## Definition of Windscreen Lower Reference Line

## **Lower Windscreen Reference Line**

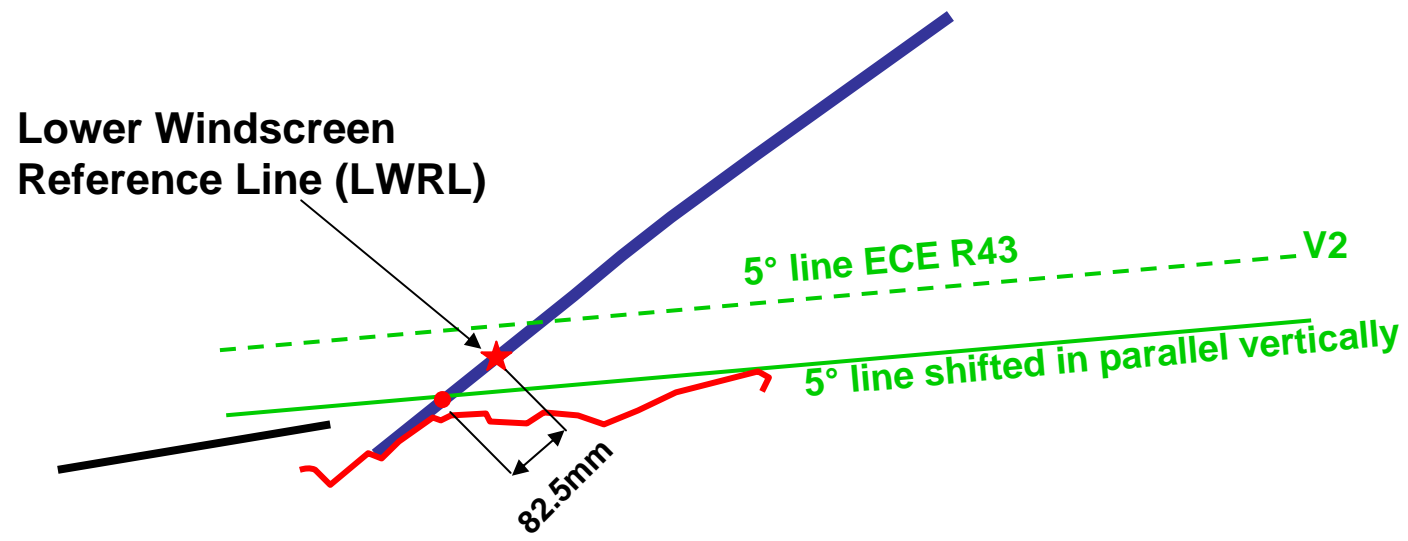
**Lower Windscreen Reference Line to be based on the definition in ECE R43**

**This definition creates a larger exemption zone for some vehicles e.g. SUVs since the 5° line crosses the windscreen near its centre**

**Unfeasibility aspects can hardly justify this basic definition**

**→ The following modified definition is proposed, shifting the 5° line vertically in parallel**

**Suggested wording:**

**The Lower Windscreen Reference Line is determined as follows:**

- **Line A is the line parallel to the 5° line described in the UN ECE-Regulation 43 (safety glazing), when the latter line is displaced vertically until it contacts the top of the dashboard**
- **Line A is then translated laterally over the width of the vehicle, while maintaining contact with the dashboard, and the trace B of all intersection points with the windscreen is determined**
- **The Lower Windscreen Reference Line is the line parallel to trace B, 82.5 mm upwards and rearwards along the windscreen.**
